**Re: Clarification of Noise Barrier Requirements (Council)
Proposed Childcare
1-23 Crowson Lane
MUNRUBEN**

Further to your request I wish to provide the following clarification with respect to the revised noise barrier designs for the above childcare centre. This letter has been prepared in response to a request from Logan City Council for confirmation that the noise barriers shown on the plans before Council achieve the noise requirements of the Planning Scheme.

ATTACHMENT 1

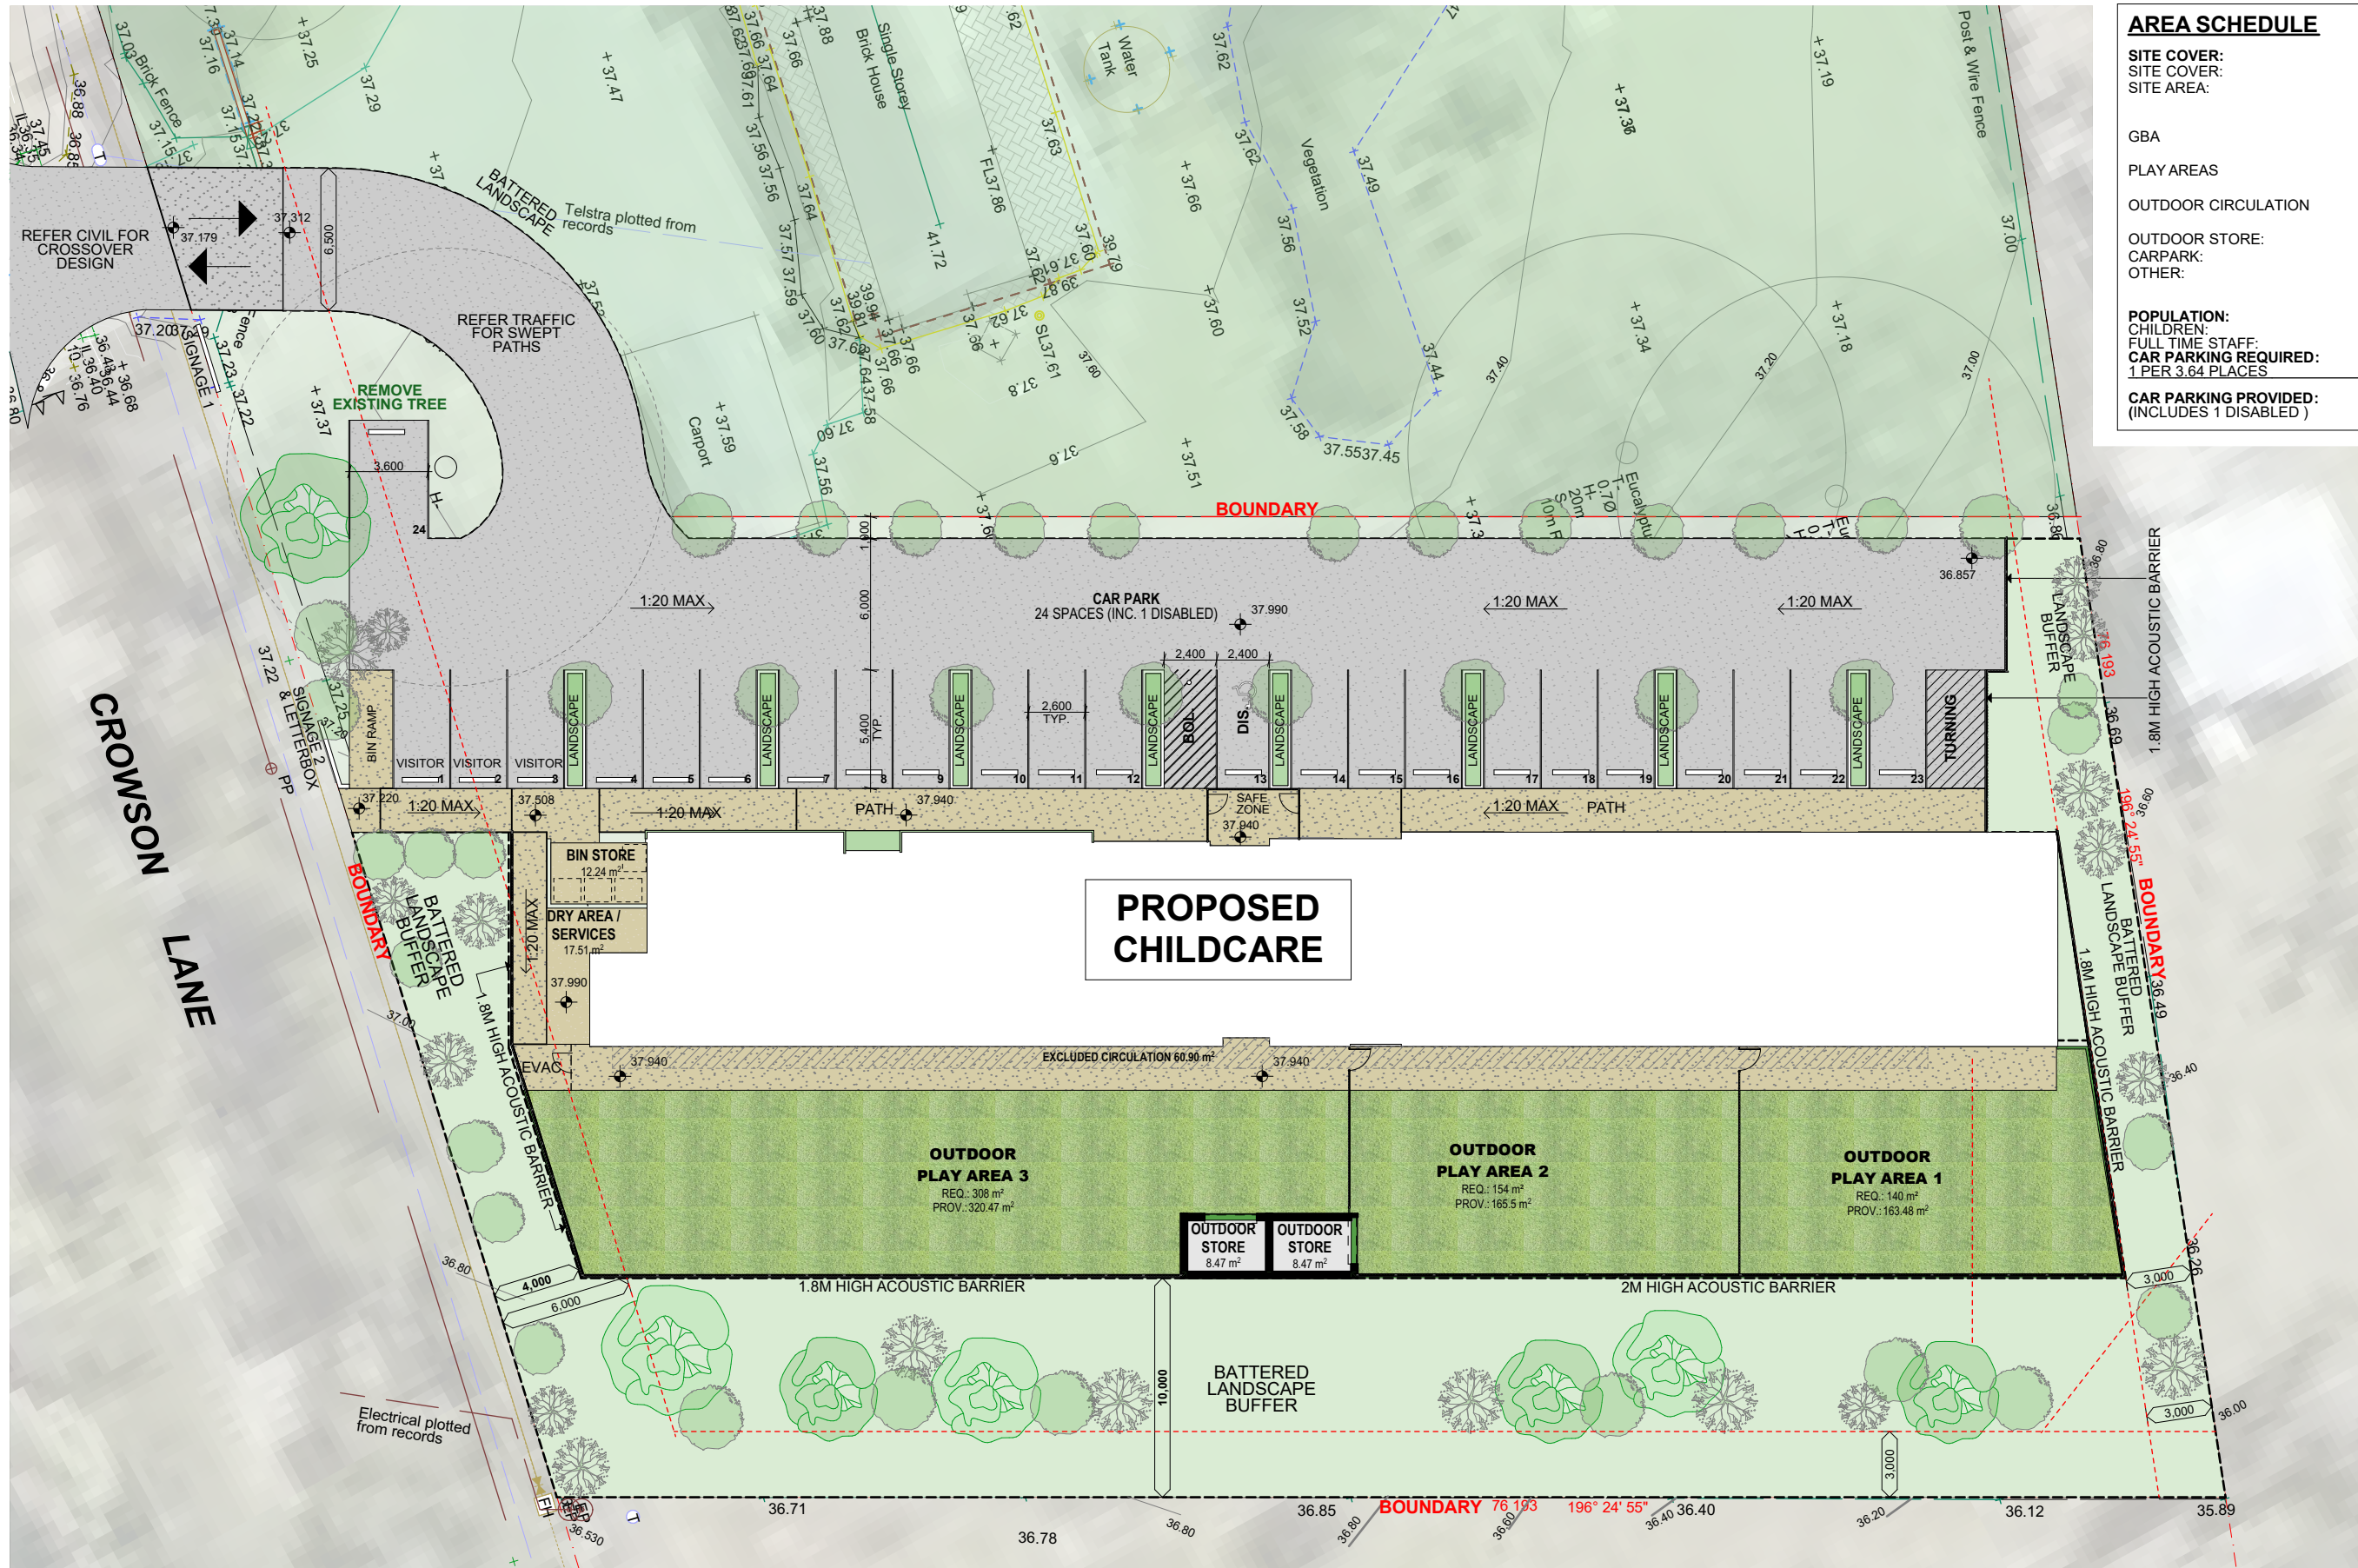
The barrier now proposed adjacent the building and outdoor play area is 1.8 metres in height whereas in earlier reporting submitted to Council in 2023, for a different site layout, a 2 metre barrier was proposed along the northern boundary. MWA have assessed the amended barrier design shown in **Attachment 1** and confirm that compliance with Logan City Council noise requirements is achieved.

I confirm that the amended layout, with a 1.8 m barrier to carpark stepped and off the boundary and a 1.8 m barrier from the building, eastwards to the edge of the outdoor play area (set in from the boundary), achieves compliance with Council planning scheme noise requirements.
